Project	IEEE 802.16 Broadband Wireless Access Working Group < http://ieee802.org/16 >	
Title	Text remedies for credit token based co-existence protocol section	
Date Submitted	2006-07-10	
Source(s)	David Grandblaise Motorola Labs Parc Les Algorithmes Commune de Saint Aubin 91193 Gif sur Yvette, France	Voice: +33 (0)1 6935 2582 Fax: +33 (0)1 6935 4801 mailto: david.grandblaise@motorola.com
Re:	Recirculation of Working Group Review of Working Document 80216h-06_015	
Abstract	This contribution provides remedies to comment #3 of the session #43's Working Group Review. The text remedies for credit token based co-existence protocol are proposed for section 15.6.2.2.6 of the working document [1].	
Purpose	Text remedies to comment #3 of the session #43's Working Group Review.	
Notice	This document has been prepared to assist IEEE 802.16. It is offered as a basis for discussion and is not binding on the contributing individual(s) or organization(s). The material in this document is subject to change in form and content after further study. The contributor(s) reserve(s) the right to add, amend or withdraw material contained herein.

Text remedies for credit tokens based rental protocol secti

Figure 45: Dynamic (iterative) credit tokens based scheduling cycle – (sequences (1) to (5))

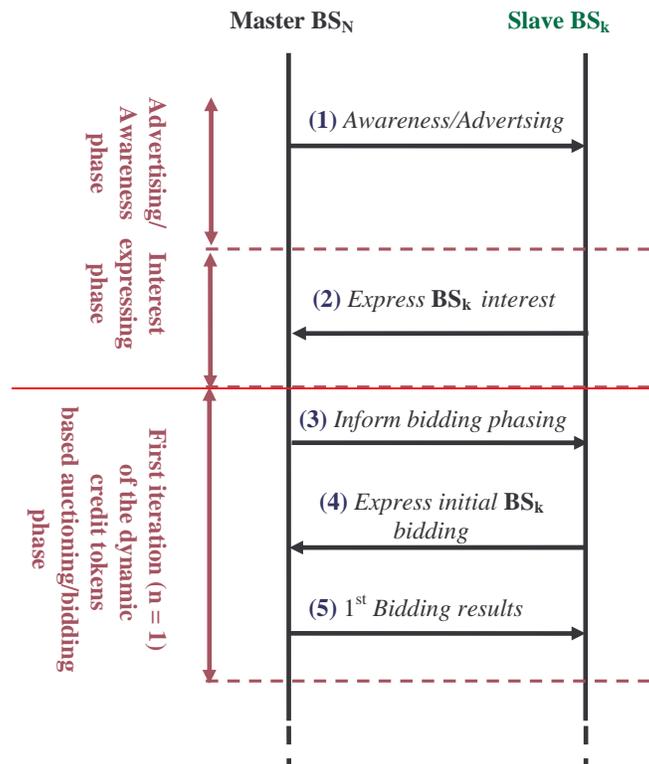
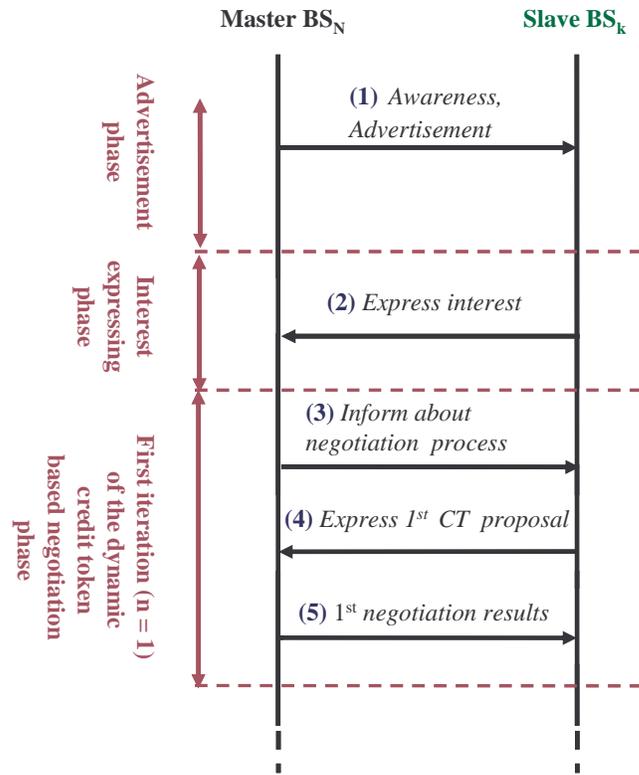
~~The contribution proposes a~~The dynamic scheduling cycle aims at coordinating between one BS_N of master NW_N and several BS_k of different slave NW_k . For the sake of simplicity, the cycle is illustrated (Figure h 45 and Figure h 46) for one BS_N and one BS_k of a given slave NW_k . The cycle is composed of different phases, and each phase can be composed of several sequences as follows.

Figure h47: Simplified MAC frame structure illustrating master NW sub-frame renting principle and associated notations

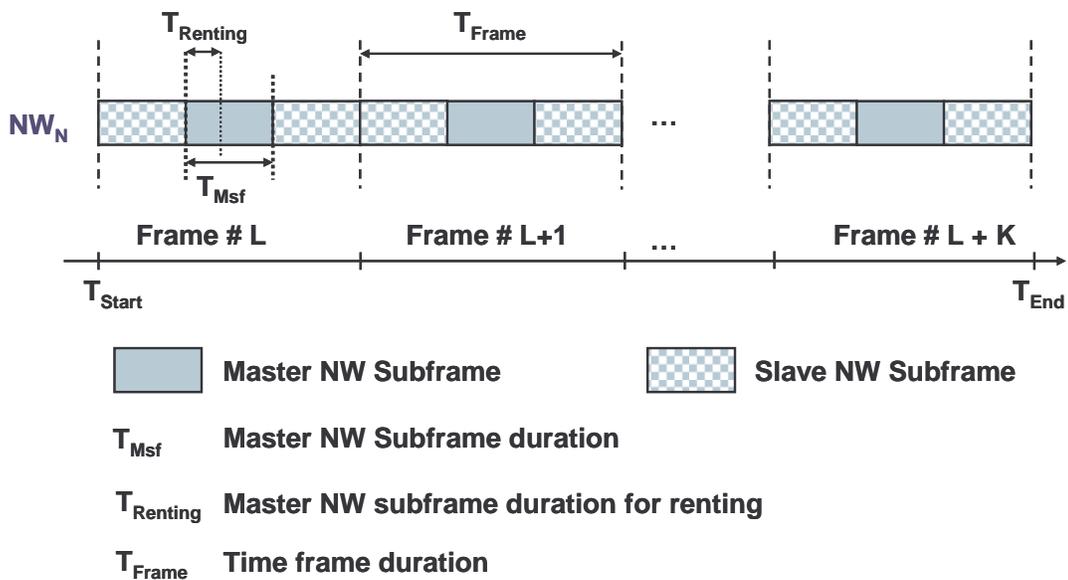
- The master NW_N (~~seller~~offeror) advertises that its periodic assigned master sub-frame is open for renting (Figure h47) from starting time T_{Start} to ending time T_{End} for a fraction ($T_{Renting}/T_{Msf}$) of its master sub-frame duration T_{Msf} . $T_{Renting} = T_{End\ Renting} - T_{Start\ Renting}$.
- The master NW_N proposes a ~~reserve price auction RPA~~ minimum number of credit tokens required (**MRCTN**) for this renting. The **RPAMRCTN** is expressed as a number of credit tokens per time unit.
